SUBJECT: Review Plan Approval for Raritan Bay and Sandy Hook Bay, New Jersey,
Hurricane and Storm Damage Reduction Project, Port Monmouth Phase II

**Review Plan for
Raritan Bay and Sandy Hook Bay, New Jersey
Hurricane and Storm Damage Reduction
Port Monmouth Phase II
Flood Risk Management Components**

PORT MONMOUTH PHASE II REVIEW PLAN COMMENTS FROM RMC

Figure 1. Project Area Location

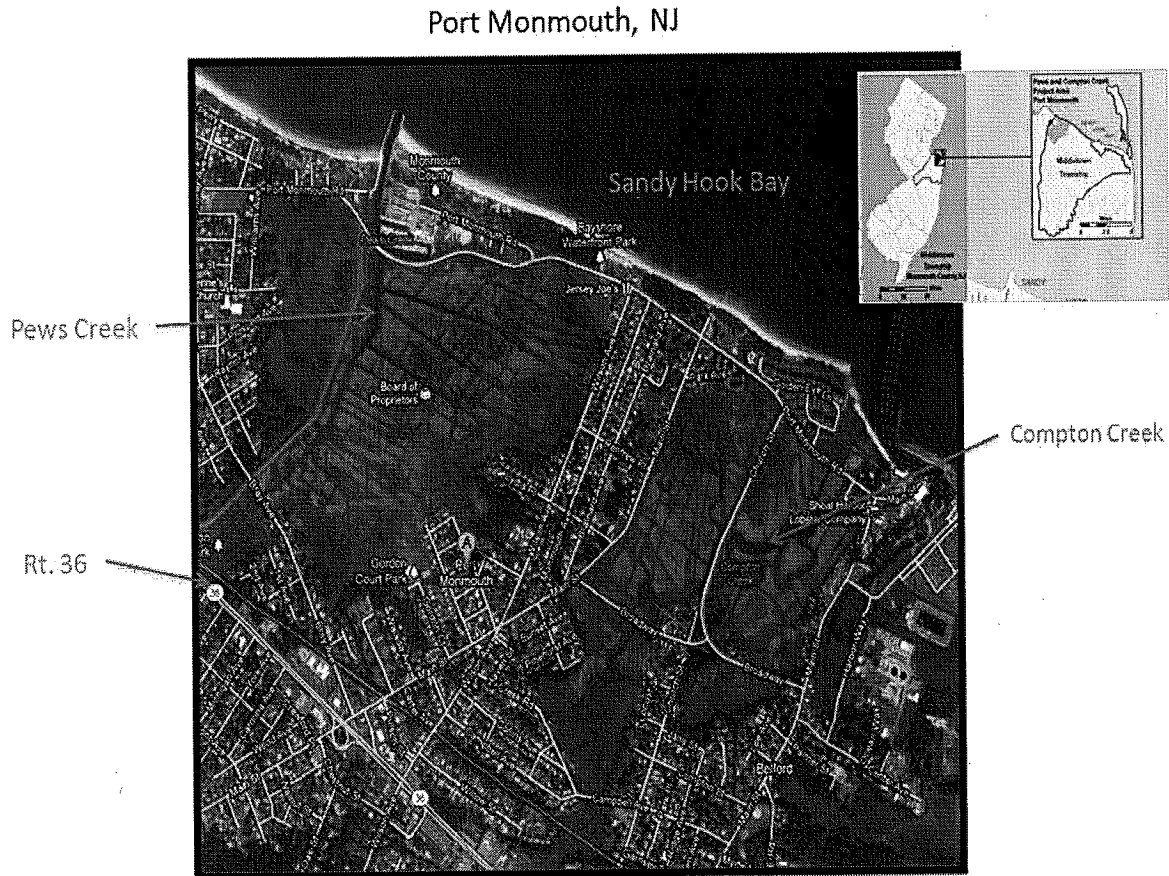
COMMENT #5. Figure 1: <<insert map of project location>>

RESPONSE: Concur. Project Location figure has been added.
